Access Compliance Report

Public Rights-of-Way

Intersection ID: 29427	Main Street: BRADSTREET_COMMONS_WY	Cross Street: SHINY_MEADOW_LN	Location: NW
ADA ID: 6FF0F46E829A	Ramp Type: Perp	Initial Pass/Fail: Fail	Overall Compliance: No
Severity Score: 33.75			
Codes/Mitigation Info/Possible Solution		Field Measurements/Component Compliance

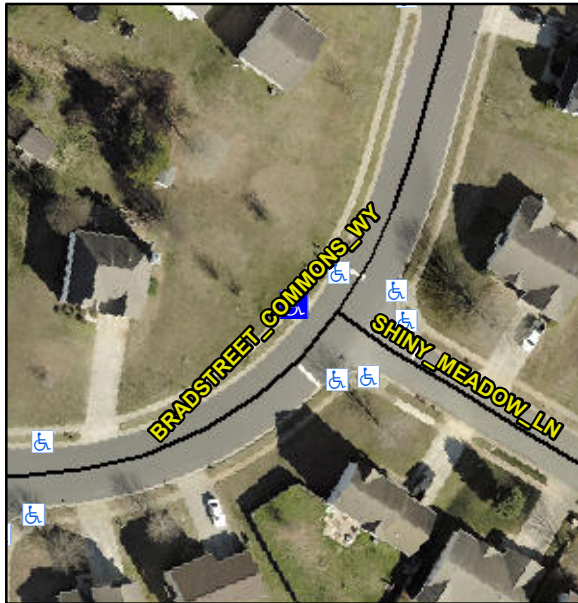
Not Found, R304.5.1, R304.2.2

Compliance	Description	Data	Compliance	Description	Data
N/A	Ramp Length (in)	49.5	No	Ramp Slope (%)	12.5
No	Ramp Width (in)	46.5	Yes	Ramp XSlope (%)	1.2
N/A	Flare Type LT	N/A	N/A	Flare Type RT	N/A
N/A	Flare Slope LT (%)	N/A	N/A	Flare Slope RT (%)	N/A
N/A	Flare Traversable LT?	N/A	N/A	Flare Traversable RT?	N/A
N/A	Landing Length (in)	N/A	N/A	DWS Provided?	N/A
N/A	Landing Width (in)	N/A	N/A	DWS Contrast?	N/A
N/A	Landing Slope (%)	N/A	N/A	DWS Length (in)	N/A
N/A	Landing X Slope (%)	N/A	N/A	DWS Full Width?	N/A
N/A	Landing Curb? (Y/N)	N/A	N/A	DWS Offset (in)	N/A
N/A	Shared Landing?	N/A			
N/A	Gutter Ponding?	N/A	N/A	Gutter Slope (%)	N/A
N/A	Gutter Lip Ht (in)	N/A	N/A	Gutter X Slope (%)	N/A
N/A	Painted X Walk1?	No	N/A	Painted X Walk2?	N/A
	X Walk 1 Direction	To SE		X Walk 2 Direction	N/A
N/A	X Walk 1 Width (in)	N/A	N/A	X Walk 2 Width (in)	N/A
	X Walk 1 Slope (%)	5.8		X Walk 2 Slope (%)	N/A
	X Walk 1 X Slope (%)	0.9		X Walk 2 X Slope (%)	N/A

Remove & Replace Entire Ramp.
